STAFF REPORT

SUBJECT: H-2022-0046

Sessions Parkway – MDA, PP

B. Proposed Conceptual Development Plans (EX1.0 and EX2.0) AND Ped Access Plans (EX1.1 and EX2.1)

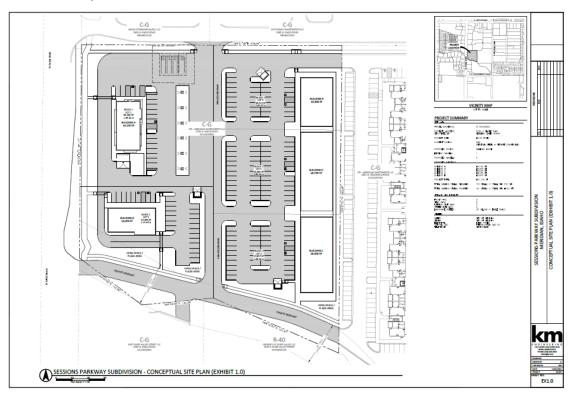
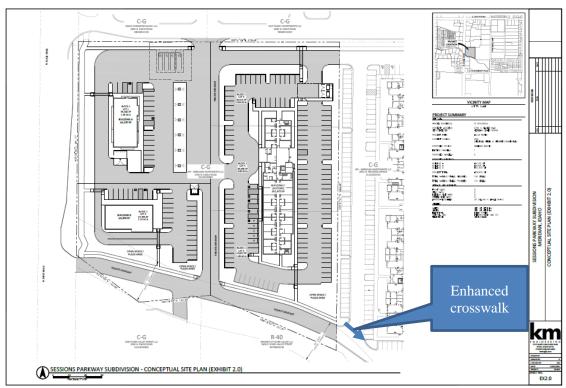
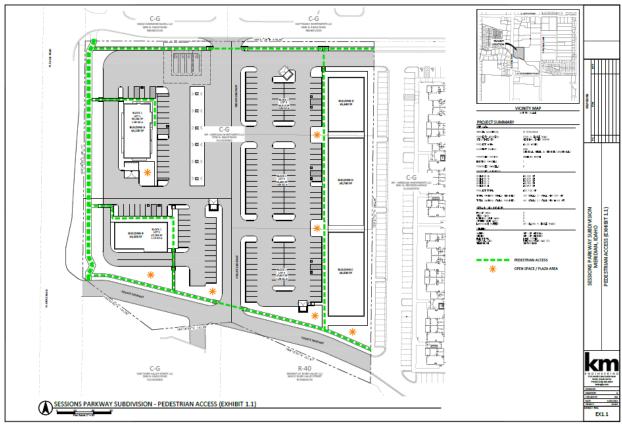
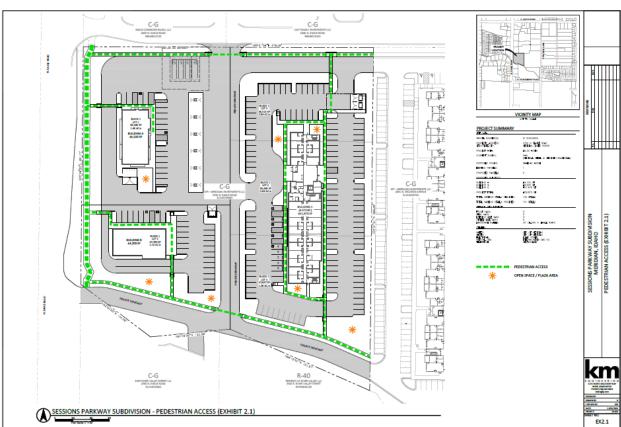
Originally, staff raised concerns that the proposed commercial development was not integrated with the future residential development to the east, nor was there a common usable gathering

area with a plaza or green space as desired in mixed use designated areas. Further, the rear of the fuel facility/convenience store faces the backage road and the rear of Buildings C, D and E face the residential development which creates a wall effect. This concern is less relevant with the second concept plan because the building placement is farther from the shared property line. Both plans have been updated to include some form of open space as desired by the Plan and the applicant has provided pedestrian circulation plans to demonstrate pedestrian movements between the commercial and future multi-family development to the east, which more closely aligns with the development guidelines in the Comprehensive Plan for Mixed Use and MU-R designated areas as noted below. However, with concept plan 1, labeled as EX1.0, some or all of the buildings along the eastern boundary should be rotated and/or relocated and a shared plaza area/green space added to a more central location within the development for better integration, including a central pathway connection to the open space and front pad sites. If the site develops consistent with concept plan 2, staff recommends that the applicant construct a 5-foot sidewalk on the east boundary and provide a decorative crosswalk across the drive aisle of the multi-family portion of the development to enhance pedestrian connectivity.

- The proposed conceptual development plan does include common usable area but it is not central to the development and is located along the southern drive aisle.

- Specific details for the integrated plaza areas have not been provided. The applicant should provide an exhibit that demonstrates compliance with this goal.

To ensure retail commercial uses don't exceed 50% of the development area and for a transition in uses, Staff recommends the concept plan is revised to depict non-retail commercial, office and/or civic uses for a minimum of 50% of the development area between the residential and retail commercial uses. The plans have not been updated to reflect this request however, the second concept plan does depict a hotel site which could limit the amount of retail that could develop on the site. The new DA should restrict the amount of retail on this site unless Commission and Council find this development shouldn't be further restricted because this property is part of a larger MU-R designated area.

- ➤ Depict non-retail commercial, office or civic uses for a minimum of 50% of the development area on Exhibit EX1.0, unless Commission or Council find this isn't applicable because this property is part of a larger MU-R designated area. This doesn't apply if the property develops with the hotel as proposed in exhibit EX2.0.

- > Specific details for the integrated plaza/open areas shall be provided with the first certificate of zoning compliance. The applicant can relocate open space/plaza areas depicted on the plan with director approval once specific tenants are known.

- > On concept plan 1, labeled as EX1.0, some or all of the buildings along the eastern boundary should be rotated and/or relocated and a shared plaza area/green space added to a more central location within the development for better integration, including a central pathway connection to the open space and front pad sites.

- ➤ If the site develops consistent with concept plan 2, labeled as EX2.0, the applicant shall construct a 5-foot sidewalk on the east boundary and provide a decorative crosswalk across the drive aisle of the multi-family portion of the development (SWC of the Village Apartments) to enhance pedestrian connectivity.

D. Landscape Plan (date: June 2022)

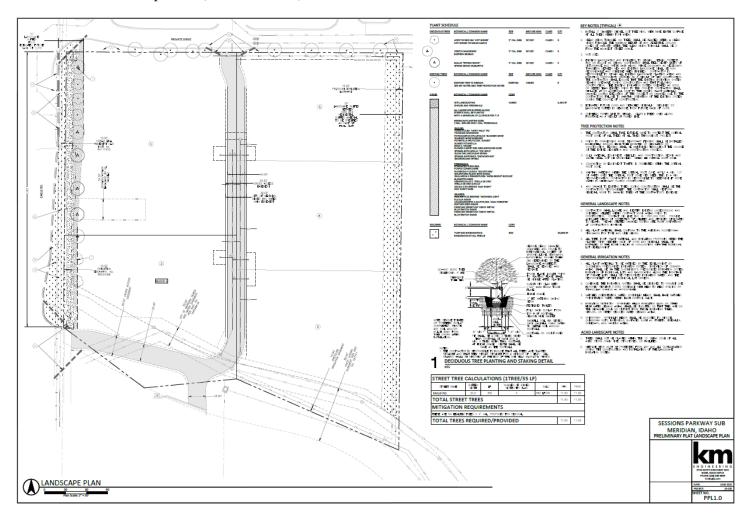
A minimum 25-foot wide buffer is required by UDC <u>Table 11-2B-3</u> in the C-G district along the eastern boundary of the site adjacent to future residential uses, landscaped per the standards in UDC <u>11-3B-9C</u>. This buffer may be installed at the time of lot development. Landscape buffers are required to facilitate safe pedestrian access between residential and commercial development as set forth in UDC <u>11-3B-9C.3</u>; the plan should be revised accordingly.

- 3. The landscape plan depicted in Section VII.D shall be revised with submittal of the final plat, as follows:
 - a. Depict landscaping within the 25-foot wide buffer along the eastern boundary of the site adjacent to residential uses in accord with the standards listed in UDC <u>11-3B-9C.1</u>; and safe pedestrian connections between commercial and residential uses as set forth in UDC <u>11-3B-9C.3</u>. Construction of the buffer may take place with lot development.

- b. Depict landscaping within the 35-foot wide street buffer along N. Eagle Rd./SH-55 in accord with the updated standards listed in UDC <u>11-3B-7C.3</u>; and pedestrian lighting and landscaping consistent with the Eagle Road Corridor study per UDC <u>11-3H-4C.3</u>.
